IN THE DRAWINGS

### REMARKS

MARKED-UP COPY

FIG.1

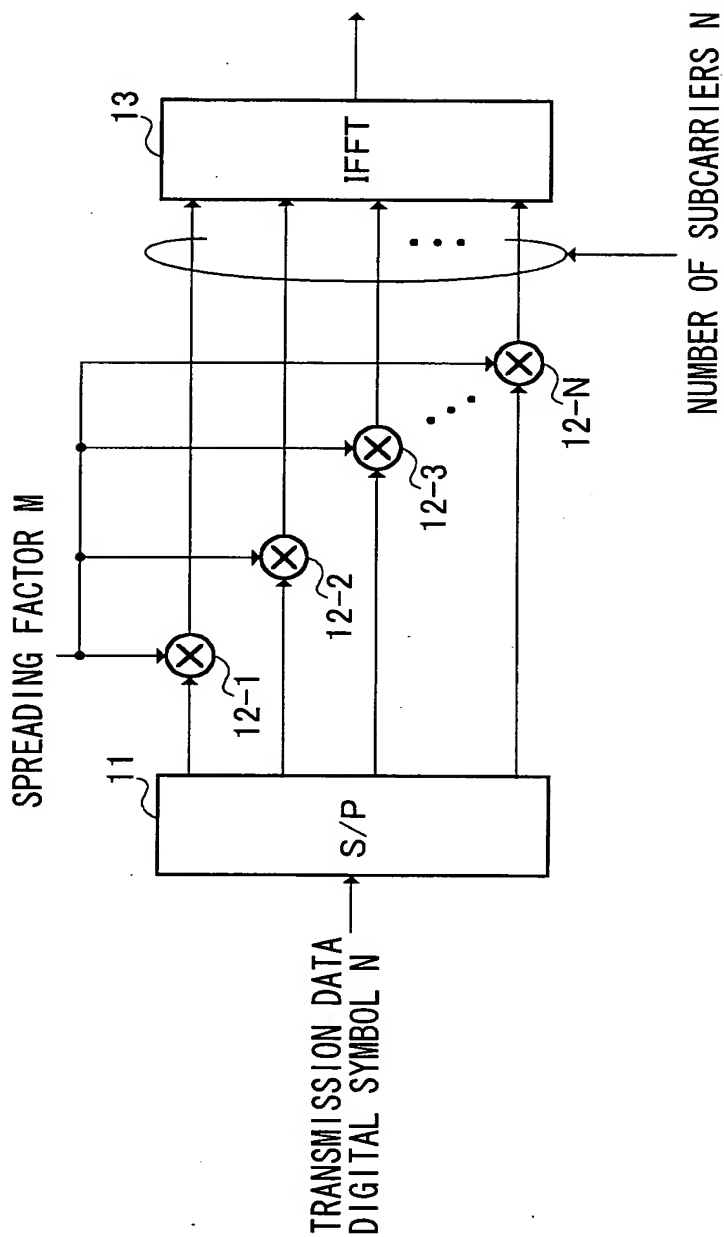
Replacement drawings for Figs. 1-7 are submitted herewith to overcome the objections thereto. Figs. 1-7 have been amended to include legends identifying them as related art.

RELATED ART
